## Mt Pleasant parking lot

August 29, 2015

Walk, field measure, observe, document, and recommend action, for Parking lot bordered by hwy 271 1<sup>st</sup> Street w Alabama and Van Buran in Mount Pleasant Texas See enclosed photo.

Exp Joint  
#1

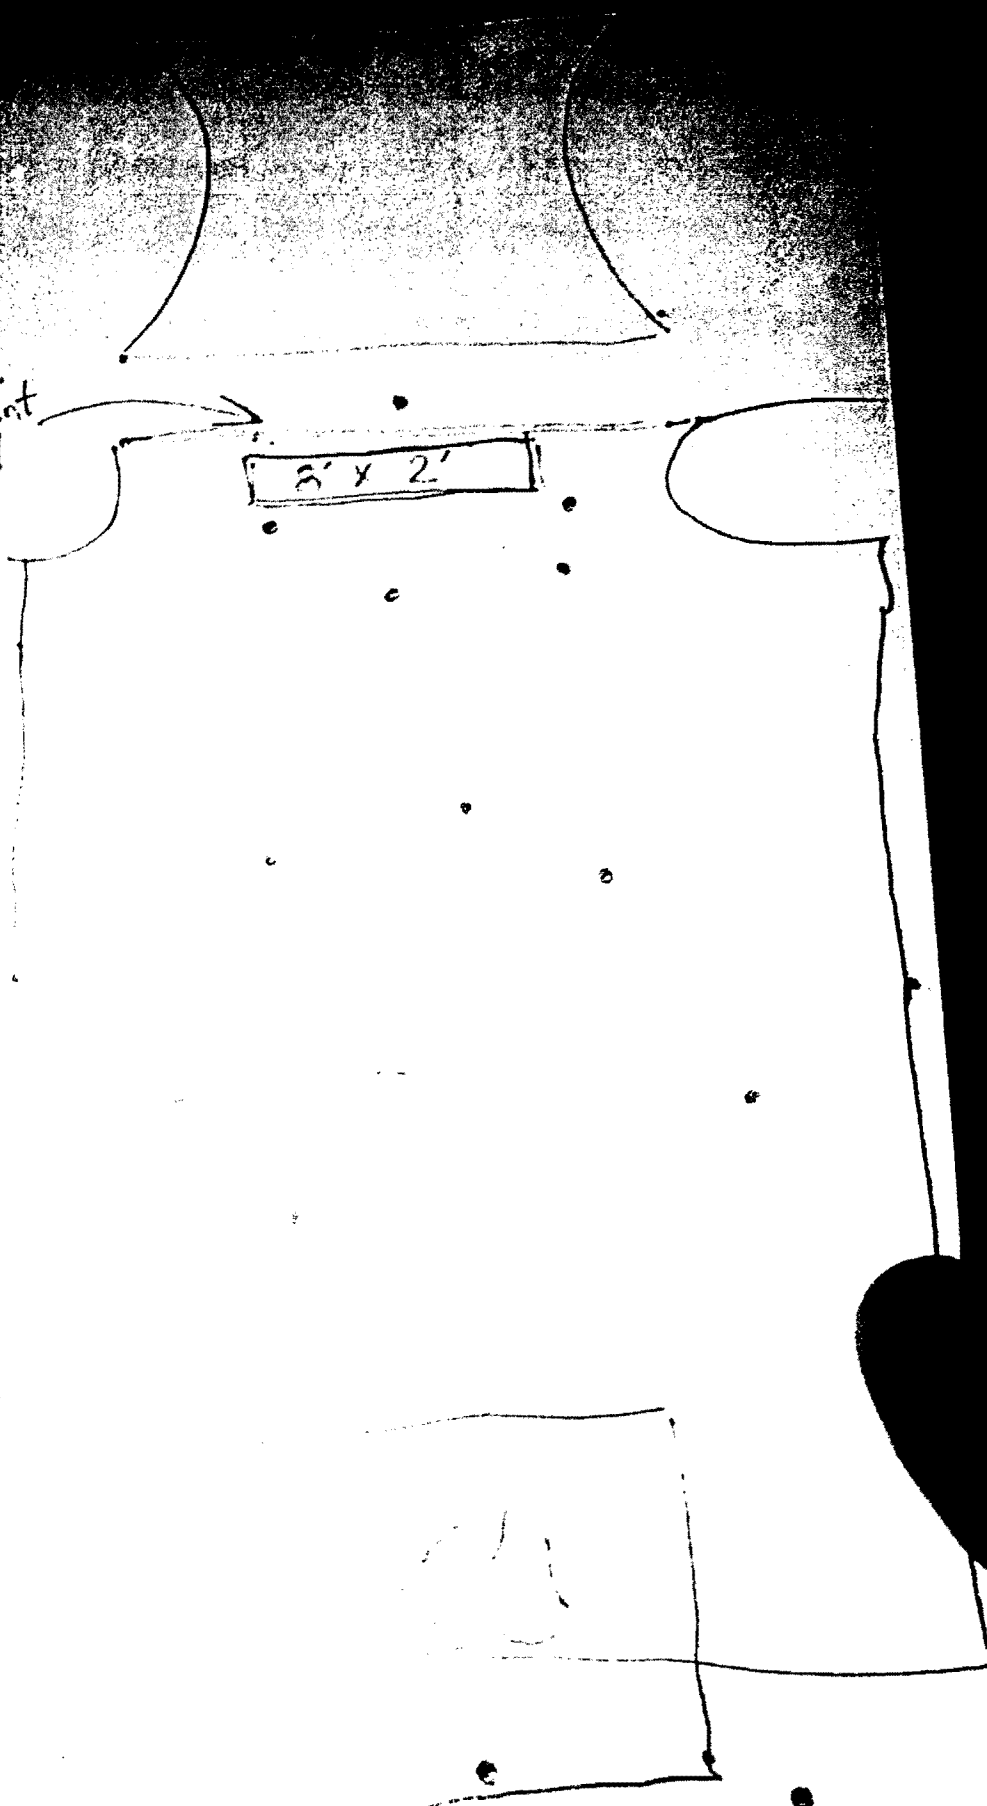
To follow up on your question regarding the size of the areas with sub grade separation. two areas of concern are located at the south most approach at the degraded expansion joint. This is an area aproxamantly 2 feet either side of the expansion joint and eight to fifteen feet wide. This area showed as much as 4 to 6 inches of separation and to the north up to within ten to twelve ft north of the hole that is coned off. This area is about ten by ten either side of the hole at 5 to 6 inches and extending out further to twenty feet 2 to 3 inches down to 1 inch at 25 ft. The first area would have 60 to 80 sf of severe separation and another sixty to eighty ft of minor separation. The second area has 150 to 200 sf of severe separation and another 100 sf of minor separation. The flowable fill material is designed to extend beyond the areas cut out and close the separation between sub grade and the underside of the paving. A stinger vibrator and flowable fill at 7 to 9 inch slump should allow the material to flow to 25 to 30 ft. Brian let me know if you need me to do anything else.

8' x 2'

3. An area located at southern most approach 8ft X 2ft should be removed and replaced with 3000 psi concrete doweled with #3 rebar drilled 6-8 inches into existing concrete and 12 inch minimum left into new concrete, these should be placed on 12 inch centers.

4. In addition an area 10ft X 10ft minimum around existing failed area should be removed and replaced utilizing the same procedure as above. This area should also include #3 rebar on 12 inch centers each way. Note this area should be increased according to subgrade separation observed at the perimeter. A mix designed with reduced large aggregate and increased sand should be placed at a high slump and allowed to flow under and replace void in additional areas adjacent to the removed concrete to be replaced. This procedure should be used for both areas to be replaced and a surface vibrator or sting vibrator, should be used to increase the flow potential of the concrete used to replace any voids beyond that of the area removed. Follow with replacement concrete mix design for pavement replacement and do not use any material other than the two mix designs. No sand shall be used to decrease depth of paving.
